Environmental Impact Statement  
Olympic Dam Expansion

# Assessment Report

## ENVIRONMENTAL IMPACT STATEMENT **Olympic Dam Expansion**

Minister for Mineral Resources Development and  
Minister for Urban Development, Planning and the City of Adelaide

SEIS Figure 22.3 Proposed alignment of access corridor, location of Port Augusta pre-assembly yard and rail crossings

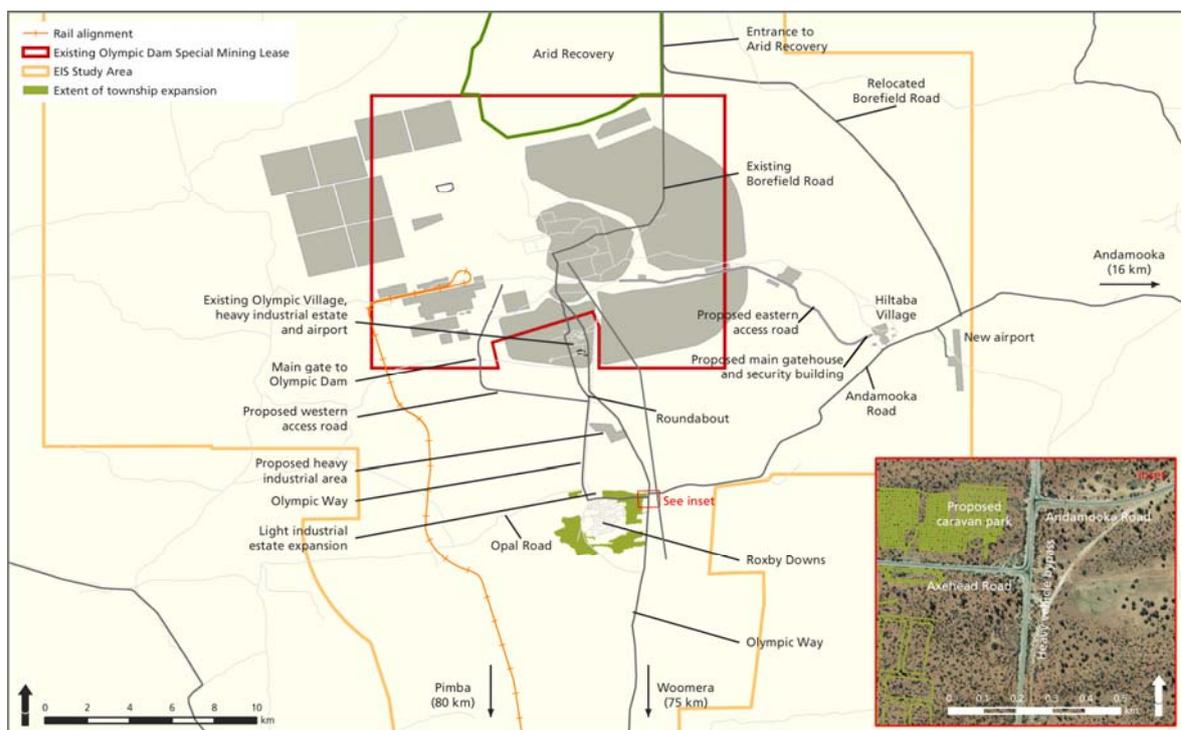
The proposed alignment of the corridor was amended in response to submissions from the SA Government and Port Augusta City Council and the final alignment shown in the Supplementary Environmental Impact Statement (SEIS) Figure 22.3.

The amended alignment of the proposed access corridor presented in the SEIS (Figure 22.3) matched the requirements and preferred alignment of the SA Government and Port Augusta City Council that was outlined in correspondence dated 31 March 2010.

- The access road from the landing facility to the pre-assembly yard in Port Augusta must be constructed in accordance with the alignment shown on SEIS Figure 22.3.
- The proponent must consult with and seek approval from DTEI, for the private access corridor from the landing facility to the pre-assembly yard, with all costs being the responsibility of BHPB.

- The access road from the landing facility to the pre-assembly yard in Port Augusta must be constructed in accordance with the alignment shown on SEIS Figure 22.3.
